Global Change Notification (GCN)

GCN Number

Current terminal positioning strip

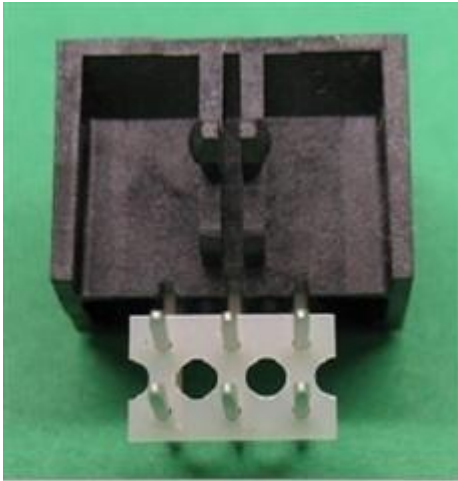
Change Description

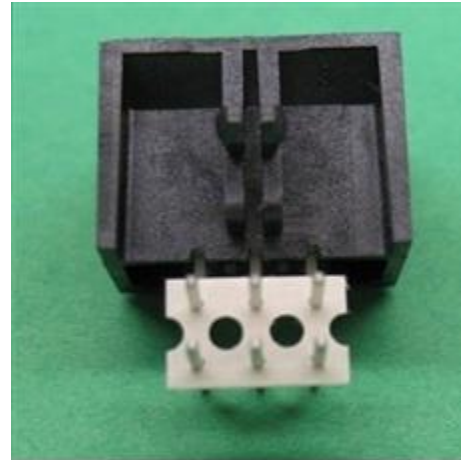
New high temperature strip capable of lead-free reflow solder temperatures. Appearance is less translucent.
